Form 3160-5
(February 2005)UNITED STATES
DEPARTMENT OF THE INTERIOR
BUREAU OF LAND MANAGEMENTFarmington Field Office
Bureau of Land ManagementFORM APPROVED
OMB No. 1004-0137
Expires: March 31, 2007

SUNDRY NOTICES AND REPORTS ON WELLS

DAKOTA PLUG BACK

ROSA UT #602

ROSA UNIT #602
BLANCO MV/BASIN MC/ BASIN DK
Proposed Wellbore Diagram

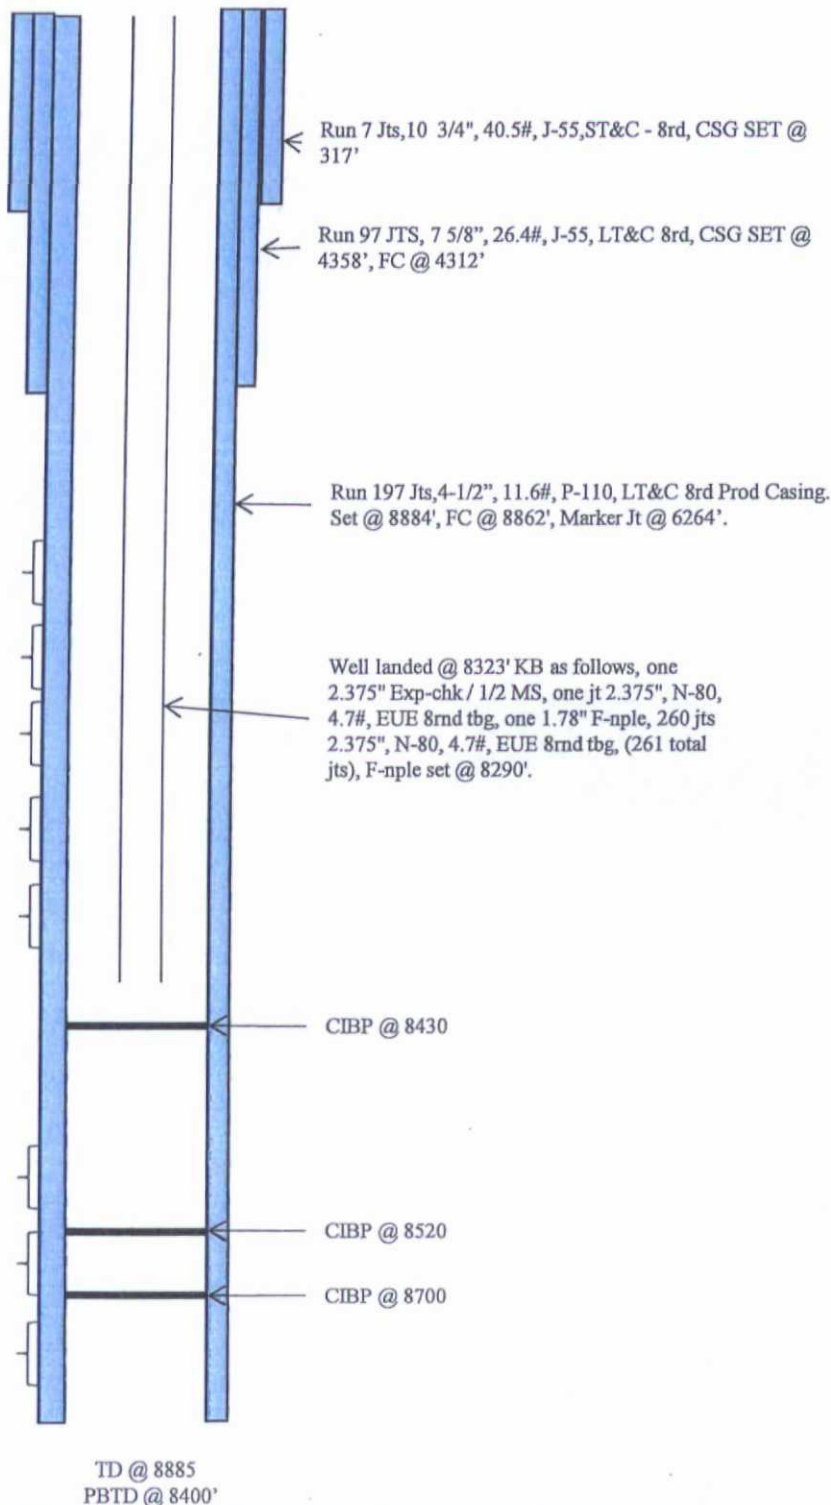
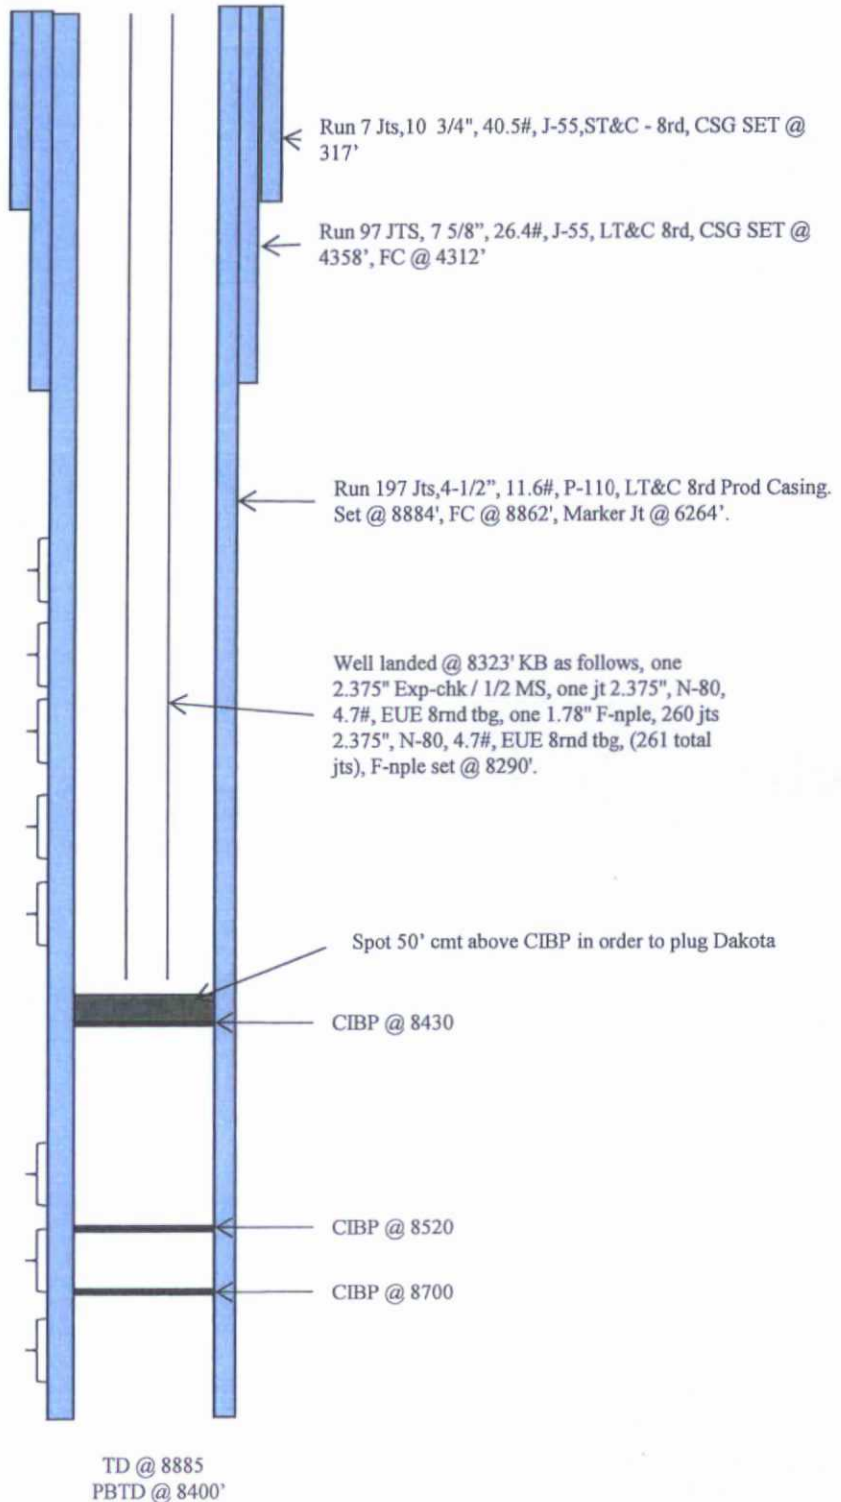
WPX Energy request to plug back the Basin Dakota per attached procedure and wellbore diagram. This well will produce as a standalone Basin Mancos; upon completion a subsequent submittal will identify the Basin Mancos with a new version of a C102 Plat.

3. RIH with tubing, softly tag CIBP @ 8430', TOO H with 2 joints.
4. Spot 50' cmt above CIBP by pumping cmt down tbg followed by displacement.
5. TOO H with tbg, landing back at original depth of 8323'.
6. RDMO rig equipment.
7. Allow 24-48 hrs for cmt to set up.
8. MIRU slickline.
9. RIH and tag TOC.
10. RDMO slickline.
11. Return well to production.

All cement plugs placed inside casing shall have sufficient volume to fill 50' of the casing, plus 100% excess of cement is required.
